UNITED STATES
DEPARTMENT OF THE INTERIOR
BUREAU OF LAND MANAGEMENT

SUNDRY NOTICES AND REPORTS ON WELLS
Do not use this form for proposals to drill or to re-enter an abandoned well. Use form 3160-3 (APD) for such proposals.

8. Well Name and No.
WEST BLINEBRY DRINKARD UNIT 39 ✓

WBDU 39W (API: 30-25-06441) Proposed Procedure

Current Wellbore Diagram

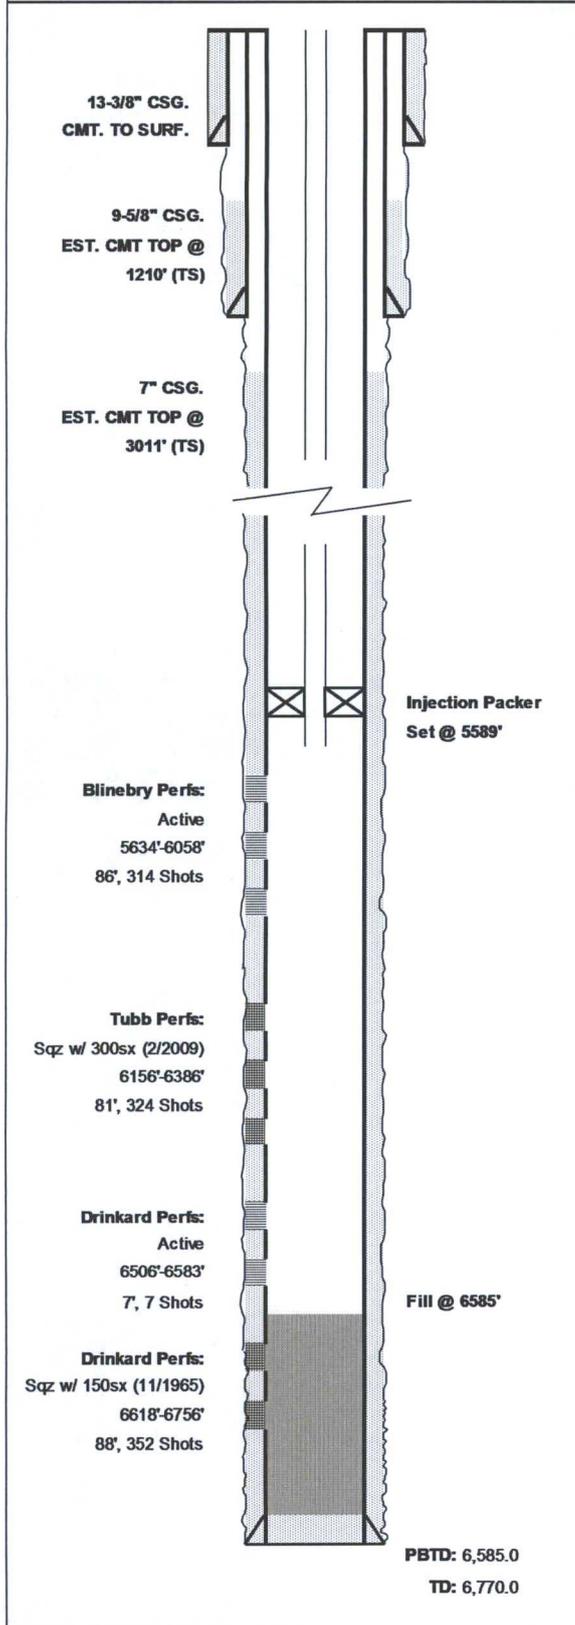
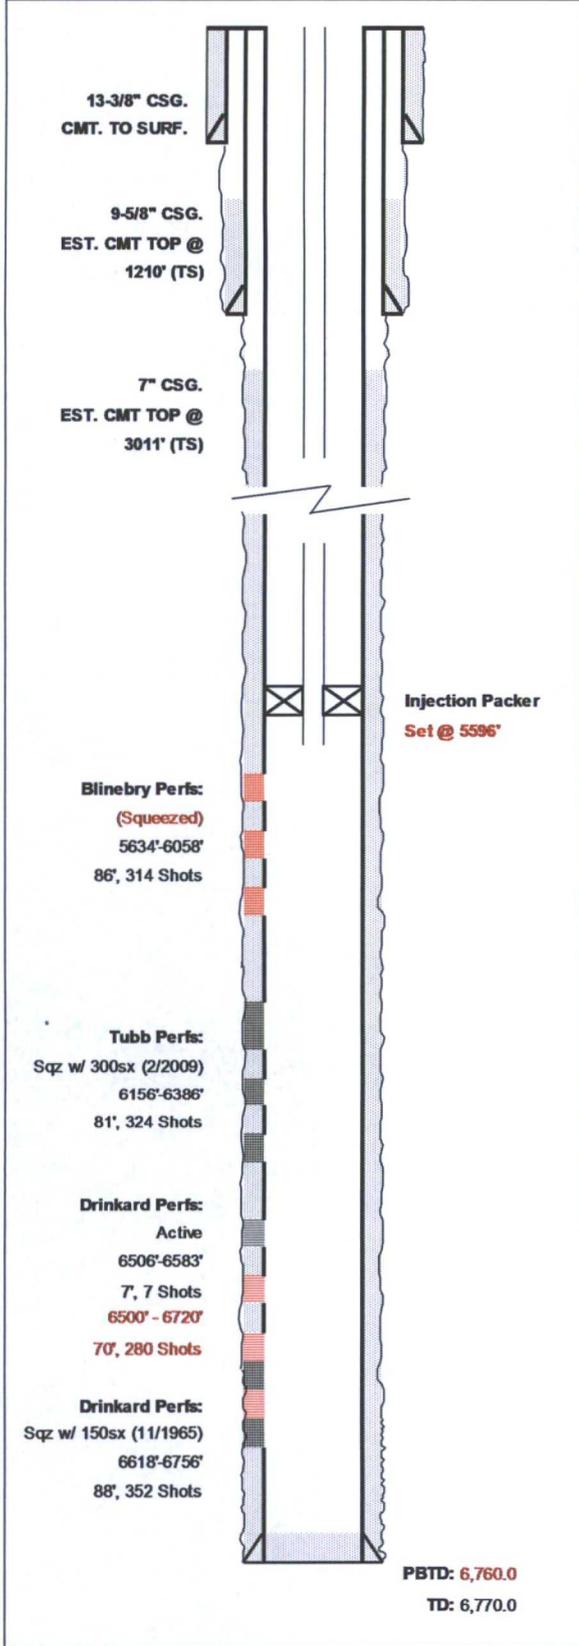
After meeting with the BLM concerning our waterflood program, Apache would like to amend our procedure to recomplete in the Drinkard portion of the formation, per the attached. This work will be completed within the next 6-12 months. Current and proposed WBD's are also attached.

Squeeze Blinebry perforations, clean out well, recomplete and stimulate Drinkard
